# UNITED STATES PATENT AND TRADEMARK OFFICE

APPLICATION NO.	FILING DATE	FIRST NAMED INVENTOR	ATTORNEY DOCKET NO.	CONFIRMATION NO.
10/033,113	10/25/2001	Allan Charles Acciacca	DP-305859	7686

<b>Office Action Summary</b>	Application No.	Applicant(s)
	10/033,113	ACCIACCA, ALLAN CHARLES
	Examiner	Art Unit
	Ryan M Flandro	3679

## **DETAILED ACTION**

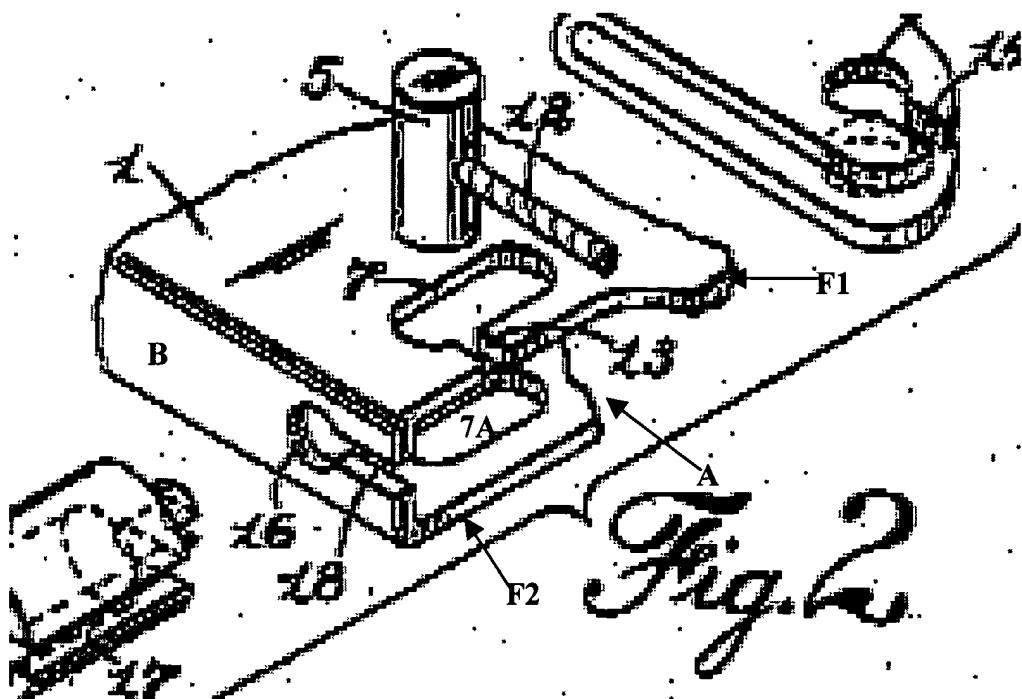
4. Claims 1-5, 8, and 9 are rejected under 35 U.S.C. 102(b) as being anticipated by Gleasman et al (US 2,854,857) (Gleasman).
  - a. Claim 1. Gleasman specifically shows a cable attachment for attaching a cable **12** to an end portion of a member **1** comprising the member **1** having an open ended loading slot **A** that extends completely across and into the end portion of the member **1** to an inner end (opposite side of surface **B**) forming separate cantilevered fingers **F1,F2** extending across the member **1** on opposite sides of the loading slot **A**, the loading slot **A**

spanning the separate fingers **F1,F2** to form openings between the fingers **F1,F2** at opposite sides of the end portion, the end portion having a retaining slot **16,18** that is transverse to the loading slot **A**, the loading slot **A** having an inner end portion (near opposite side of surface **B**) and the retaining slot **16,18** having an outer end portion **18** that overlaps the inner end portion of the loading slot **A**, the end portion having a first transition slot **7** that extends from one of the opposite sides of the end portion through one of the fingers **F1** into the inner end portion of the loading slot **A** and the overlapping outer end portion **18** of the retaining slot **16,18**, the end portion having a second transition slot **7A** that extends from another of the opposite sides of the end portion through another of the fingers **F2** into the inner end portion of the loading slot **A** and the overlapping outer end portion **18** of the retaining slot **16,18**, and the cable **12** extending through the retaining slot **16,18** and having a ferrule **5** that engages a surface of the end portion adjacent the retaining slot **16,18** for moving the member **1**, the cable **12** being moveable axially in the retaining slot **16,18** to form a lost motion attachment with the end portion of the member **1** (see annotated figure 2 below; columns 1 and 2).

b. Claim 2. Gleasman, as applied to claim 1 above, also shows the cable 12 loaded into the retaining slot 16,18 through the loading slot A and the first and the second transition slots 7,7A (see annotated figure 2 above).

c. Claim 3. Gleasman also shows the second transition slot 7A is coplanar with the first transition slot 7 (see annotated figure 2 above – plane normal to surfaces **F1 and B**).

d. Claim 4. Gleasman also shows the retaining slot 16,18 as being linear (see annotated figure 2 above).

e. Claim 5. Gleasman also shows that the retaining slot 16,18 being shaped to inhibit escape of the cable 12 transverse to its axis (see annotated figure 2 above).

f. Claim 8. Gleasman, as applied above, shows a cable attachment for attaching a cable 12 to an end portion of a moveable member 1 comprising the member 1 having an open ended loading slot A that extends completely across and into the end portion of the member 1 to an inner end (opposite side of surface B) forming separate parallel

cantilevered fingers **F1,F2** on opposite sides of the loading slot **A**, the loading slot **A** spanning the separate fingers **F1,F2** to form openings between the fingers **F1,F2** at opposite sides of the end portion, the end portion having a retaining slot **16,18** that is perpendicular to the loading slot **A**, the loading slot **A** having an inner end portion (near opposite side of surface **B**) and the retaining slot **16,18** having an outer end portion **18** that overlaps the inner end portion of the loading slot **A**, the end portion having a first transition slot **7** that is perpendicular to the loading slot **A** and the retaining slot **16,18** and that extends from one of the opposite sides of the end portion through one of the fingers **F1** into the inner end portion of the loading slot **A** and the overlapping outer end portion **18** of the retaining slot **16,18**, the end portion having a second transition slot **7A** that is aligned with the first transition slot **7** and that extends from another of the opposite sides of the end portion through another of the fingers **F2** into the inner end portion of the loading slot **A** and the overlapping outer end portion **18** of the retaining slot **16,18**, and the cable **12** extending through the retaining slot **16,18** and having a ferrule **5** that engages a surface of the end portion (opposite side of surface **B**) adjacent the retaining slot **16,18** for moving the member **1**, the cable **12** being moveable axially in the retaining slot **16,18** to form a lost motion attachment with the end portion of the moveable member **1** (see annotated figure 2 above; columns 1 and 2).

g. Claim 9. Gleasman provides a member **1** having an open ended loading slot **A** that extends into an end portion of the member **1** to an inner end (opposite side of surface **B**) forming separate cantilevered fingers **F1,F2** on opposite sides of the loading slot **A**, the loading slot **A** spanning the separate fingers **F1,F2** to form openings between the

fingers **F1,F2** at opposite sides of the end portion, a retaining slot **16,18** that is transverse to the loading slot **A**, the loading slot **A** having an inner end portion (near opposite side of surface **B**) and the retaining slot **16,18** having an outer end portion **18** that overlaps the inner end portion of the loading slot **A**, a first transition slot **7** that extends from one of the opposite sides of the end portion through one of the fingers **F1** into the inner end portion of the loading slot **A** and the overlapping outer end portion **18** of the retaining slot **16,18**, and a second transition slot **7A** that extends from another of the opposite sides of the end portion through another of the fingers **F2** into the inner end portion of the loading slot **A** and the overlapping outer end portion **18** of the retaining slot **16,18**, a cable **12** having a ferrule **5** attached to it (see annotated figure 2 above; columns 1 and 2).

Gleasman further shows and discloses the step of inserting an end length of the cable **12** transversely into the loading slot **A** until the cable **12** is disposed in the inner end portion of the loading slot **A**, rotating the end length of the cable **12** in a planar fashion through the first and second transition slots **7,7A** until the length of the cable **12** is aligned with the retaining slot **16,18**, and inserting the end length of the cable **12** into the retaining slot **16,18** so that the cable **12** is moveable axially in the retaining slot **16,18** and the ferrule **5** is engagable with a surface (opposite side of surface **B**) of the member **1** adjacent the retaining slot **16,18** (see figure 1 and annotated figure 2 above).

a. Claim 6. Gleasman specifically shows a cable attachment for attaching a cable 12 to an end portion of a member 1 comprising the member 1 having an open ended loading slot A that extends completely across and into the end portion of the member 1 to an inner end (opposite side of surface B) forming separate cantilevered fingers F1,F2 extending across the member 1 on opposite sides of the loading slot A, the loading slot A spanning the separate fingers F1,F2 to form openings between the fingers F1,F2 at opposite sides of the end portion, the end portion having a retaining slot 16,18 that is transverse to the loading slot A, the loading slot A having an inner end portion (near opposite side of surface B) and the retaining slot 16,18 having an outer end portion 18 (opposite side of surface B) that overlaps the inner end portion of the loading slot A, the end portion having a first transition slot 7 that extends from one of the opposite sides of

the end portion through one of the fingers **F1** into the inner end portion of the loading slot **A** and the overlapping outer end portion **18** of the retaining slot **16,18**, the end portion having a second transition slot **7A** that extends from another of the opposite sides of the end portion through another of the fingers **F2** into the inner end portion of the loading slot **A** and the overlapping outer end portion **18** of the retaining slot **16,18**, and the cable **12** extending through the retaining slot **16,18** and having a ferrule **5** that engages a surface of the end portion adjacent the retaining slot **16,18** for moving the member **1**, the cable **12** being moveable axially in the retaining slot **16,18** to form a lost motion attachment with the end portion of the member **1**; the retaining slot **16,18** shaped to inhibit escape of the cable **12** transverse to the axis of the cable **12**; the outer end portion **18** of the retaining slot **16,18** is linear and the retaining slot **16,18** has a curved intermediate portion **16** that inhibits movement of the cable **12** transversely in the retaining slot **16,18** (see annotated figure 2 above; columns 1 and 2).
